**METROPOLITAN GOVERNMENT OF NASHVILLE AND DAVIDSON COUNTY**

**STAFF RECOMMENDATION**  
**1410 Gale Lane**  
**December 19, 2012**

**Application:** New construction—addition; Demolition—outbuildings; Setback Reduction

**District:** Belmont-Hillsboro Neighborhood Conservation Zoning Overlay

**SCHEME II**  
SCALE: 1" = 20'-0"

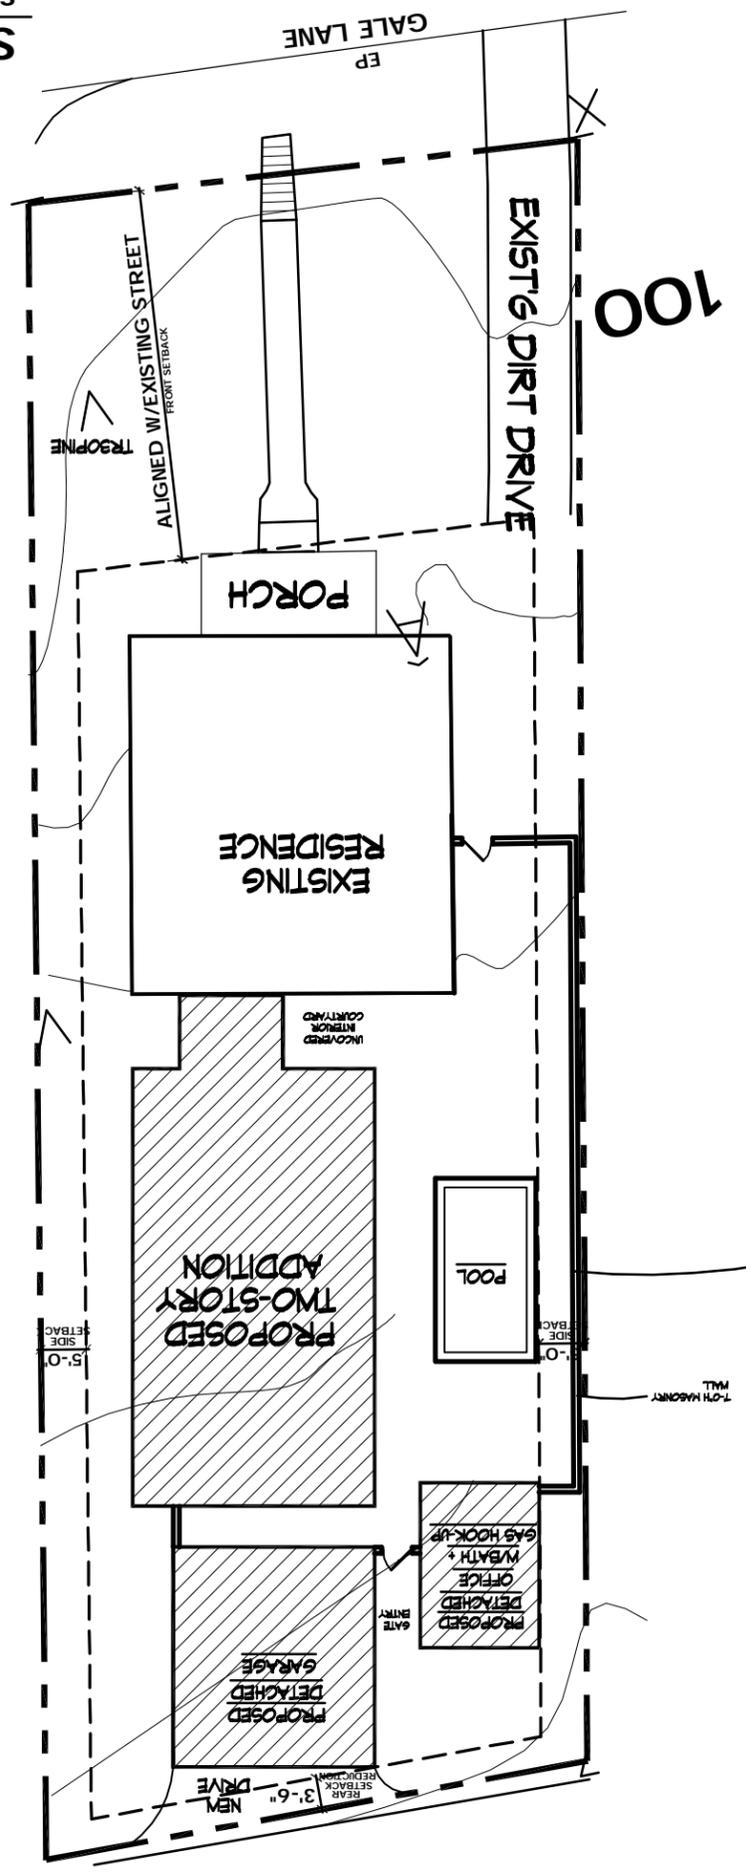
**Location & Setbacks:** The application includes two outbuildings located toward the rear of the property. For structures with garage doors facing the alley, Codes requires a rear setback of ten feet (10'), but only three feet, six inches (3'6") is proposed for this new garage. Because the locations of historic outbuildings were of minimal distance from the rear alley and the fact that within the immediate context several outbuildings are located a minimal distance from the alley, staff finds the reduction of the rear setback appropriate.

NOTE: VERIFY W/NEIGHBOR TO ALLOW FOR WALL TO SIT ON SETBACK LINE.

**EXISTING FIRST FLOOR PLAN/DEMO**

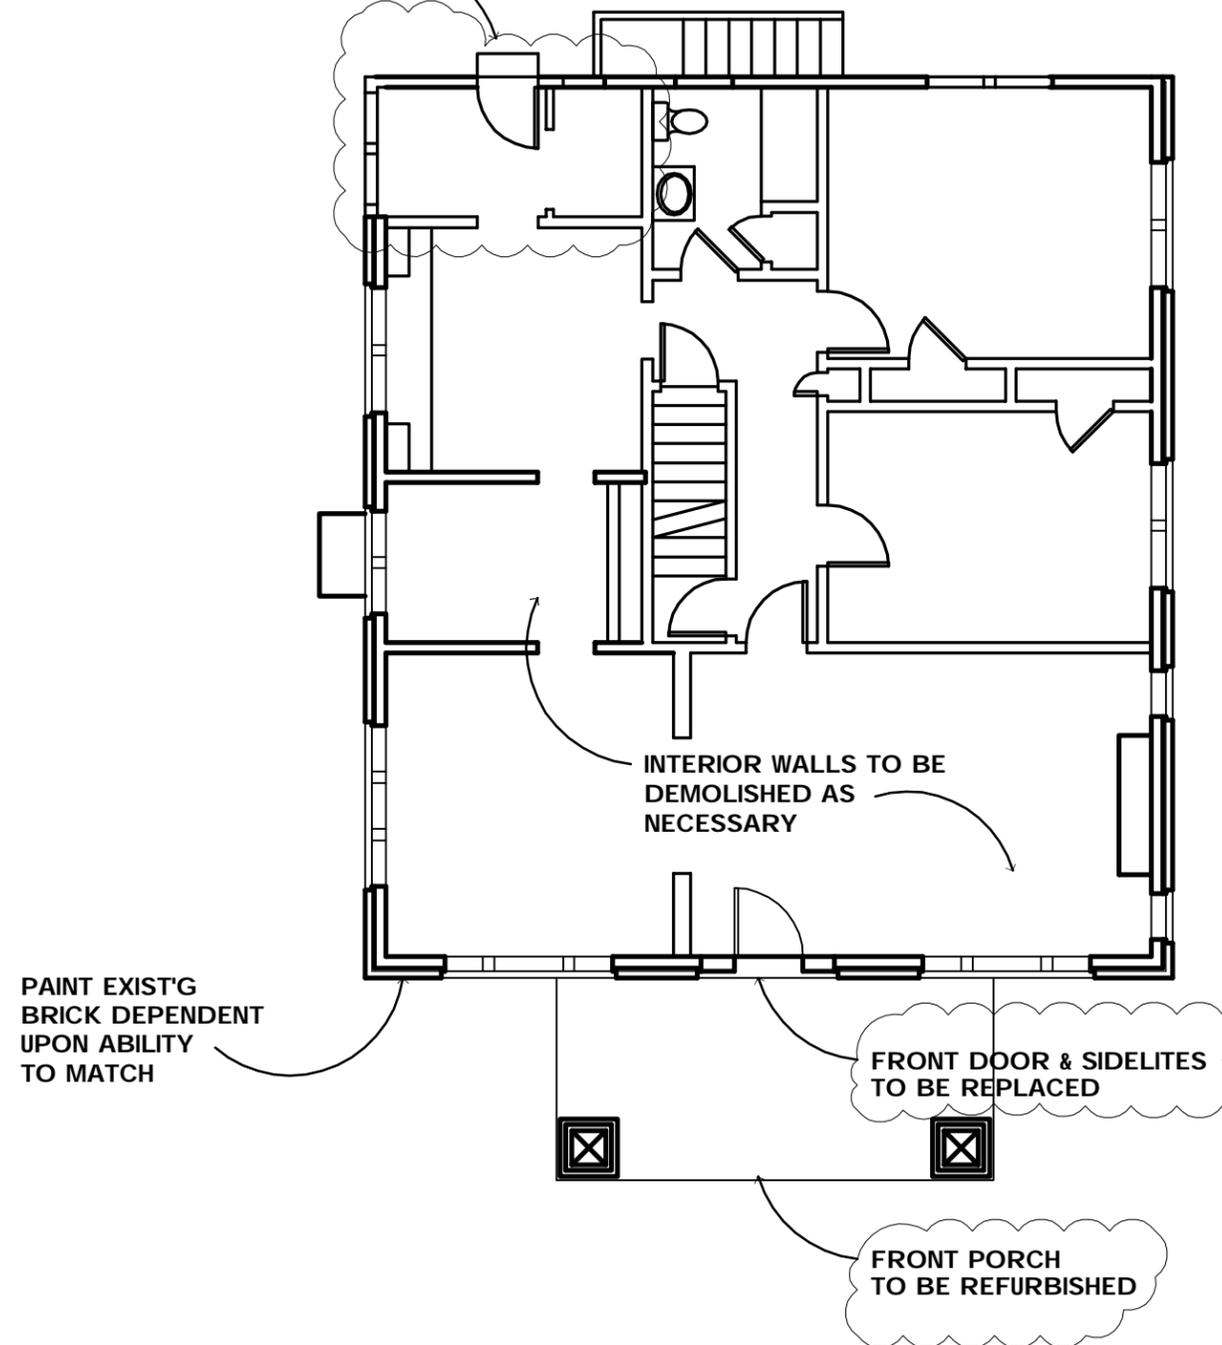
Materials, Texture, and Details and Material Color: The addition will primarily be clad in brick veneer to match the existing house. The left rear corner of the existing house, currently lap sided, will be replaced with brick to match the rest of the house. The portion of the addition connecting the existing house with the addition will be clad in cement fiberboard siding, and have a minimum of a five inch (5") reveal. The addition's foundation will be split-faced concrete block, and the roof will be asphalt shingles (color dark gray but subject to change).

EXTERIOR WOOD CORNER  
TO BE DEMOLISHED

**LEFT ELEVATION**

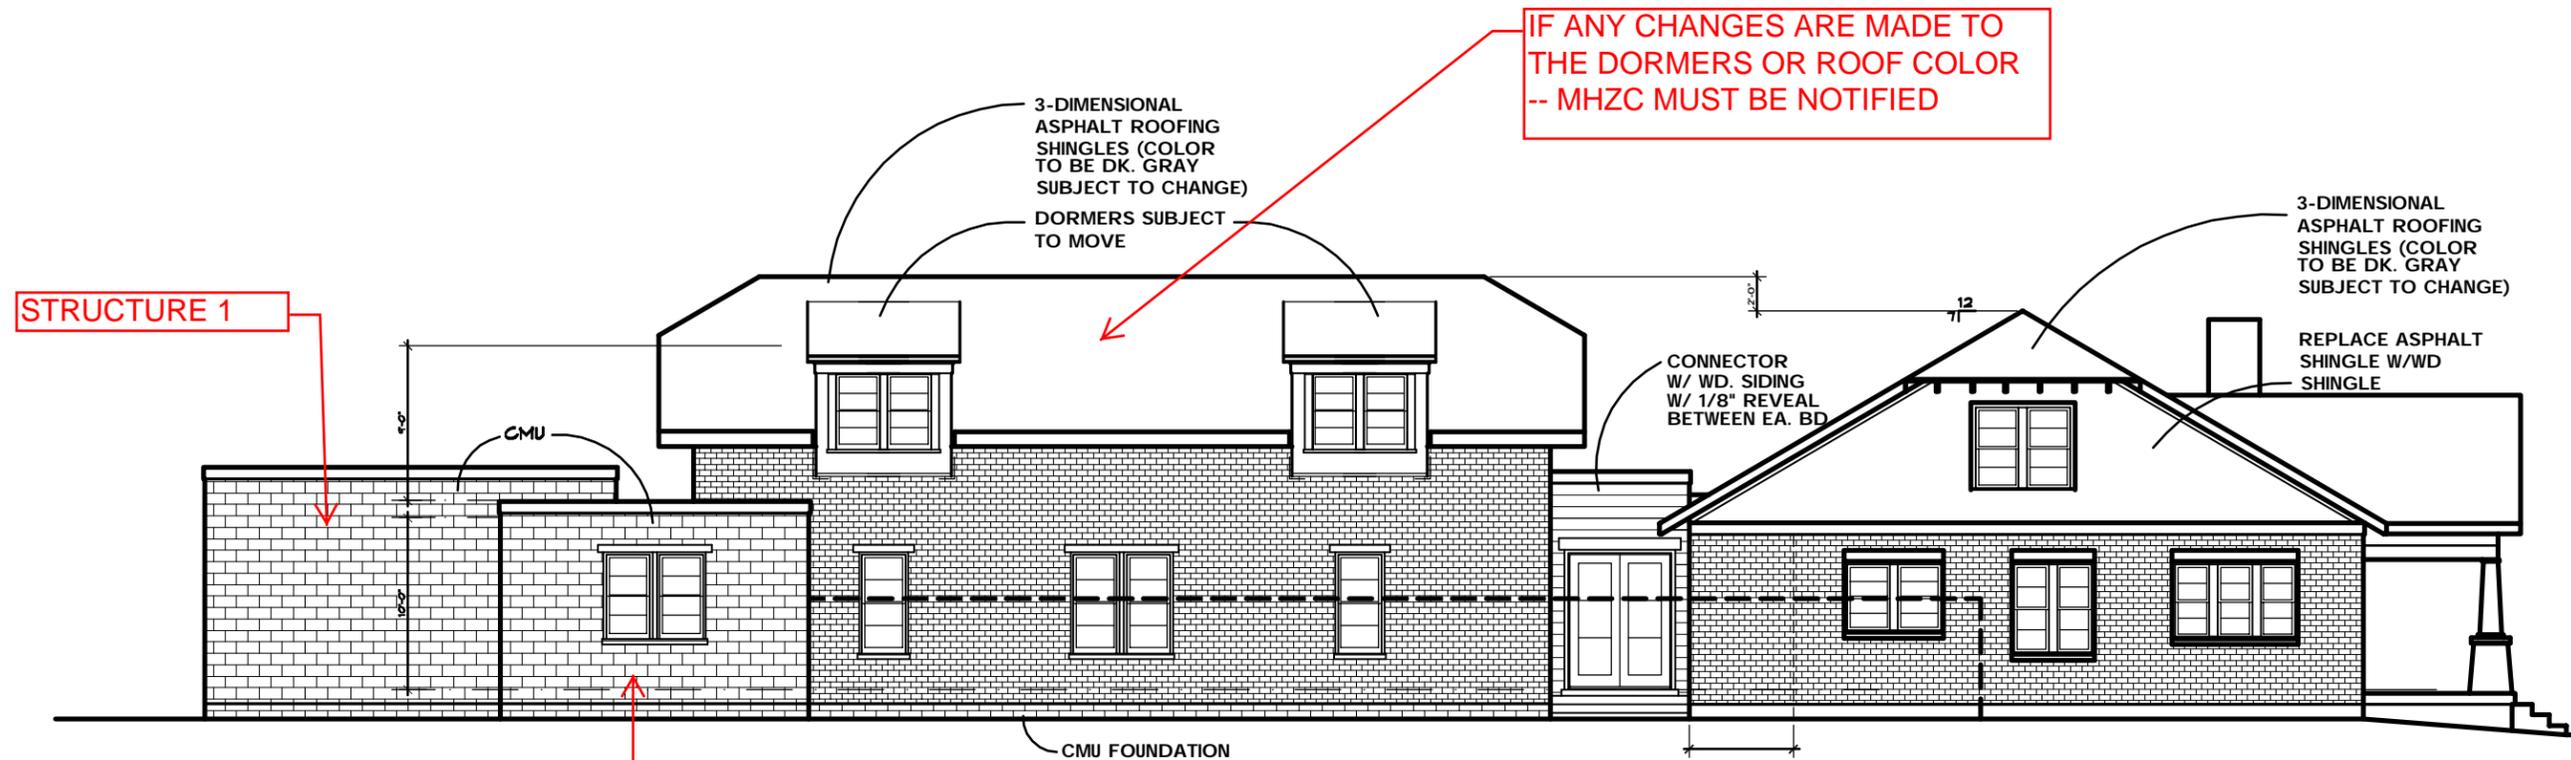
Roof: The 7/12 roof slope of the main body of the addition, will be similar to the existing house and what is typical for the district. There are two side wall dormers proposed on each side of the addition for a total of four dormers. The ridge of the dormers will be two feet (2') below the ridge of the addition and are compatible with the scale and design of the existing house and proposed addition. Because wall dormers are so rare within the district, the Commission typically does not allow them; however, in this case they are on a secondary elevation, located towards the rear, and are small in scale.

IF ANY CHANGES ARE MADE TO THE DORMERS OR ROOF COLOR -- MHZC MUST BE NOTIFIED

**FRONT ELEVATION**

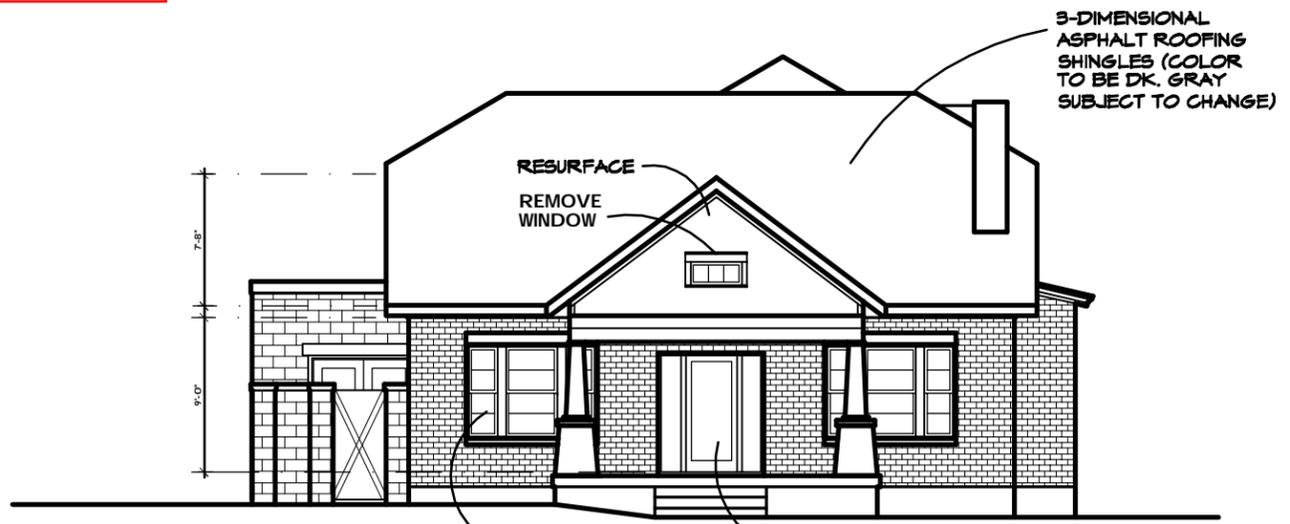
The proposed addition will be approximately two foot (2') taller than the existing house and will connect to the house with a flat roofed structural alcove that is shorter than the existing house. The additional height does not happen until approximately forty-eight feet (48') beyond the front wall of the house. In the past, the Commission has allowed for buildings that are as much as four feet (4') taller than the existing house as long as the additional height does not take place until at least forty feet (40') from the front wall the house. The proposed addition more than meets that condition. The portion of the roof that will be visible will have a clipped gable roof decreasing the visual mass and the visibility of the addition. The foundation line of the addition will be the same height as the existing foundation line.
